ADDENDUM 2 BID OPPORTUNITY NO. 153-2005

WINNIPEG WATER TREATMENT PROGRAM – CONSTRUCTION OF YARD
PIPING AND VALVE CHAMBERS - CONTRACT 1

ISSUED: May 6, 2005
BY: Larry Smith, C.E.T., UMA Engineering Ltd.
TELEPHONE NO. (204) 204-0580

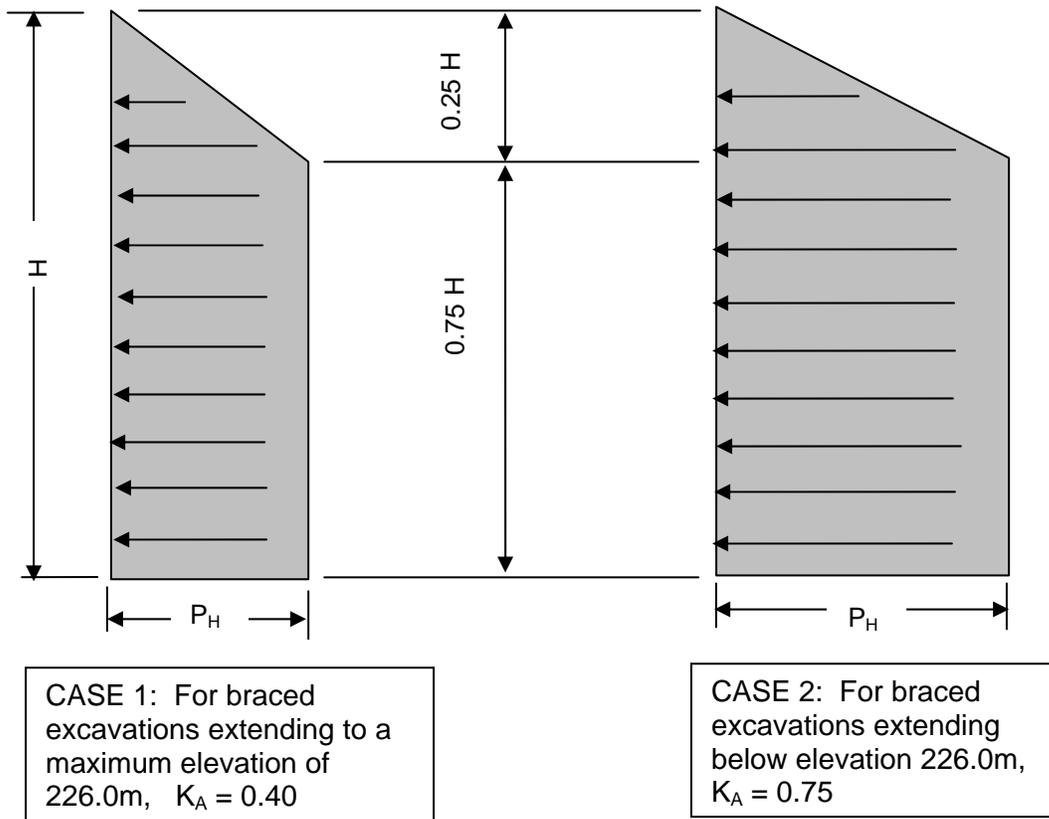
Add: E11.2.4 Earth Pressures

To aid Bidders in determining the shoring requirements for this project, the following geotechnical parameters and earth pressure distributions are provided. For more information, Bidders are referred to the geotechnical information presented in Section 15 of the City of Winnipeg Water Treatment Plant Preliminary Design Report (2005) available for viewing at the offices of UMA Engineering Ltd., 1479 Buffalo Place, Winnipeg, MB.

Earth pressure distributions for both Case 1 and Case 2 are calculated using the following general equation:

$$P_H = K_A \gamma H$$

Where: P_H = Lateral Earth Pressure (kPa)
 K_A = Active Earth Pressure Coefficient (use values shown above for Case 1 and Case 2)
 γ = Soil Unit Weight = 17.5 kN/m³
 H = Depth of Excavation (m)

The submission of shop drawings and loading diagrams will be required for all designs that include these or any other earth pressure distributions.
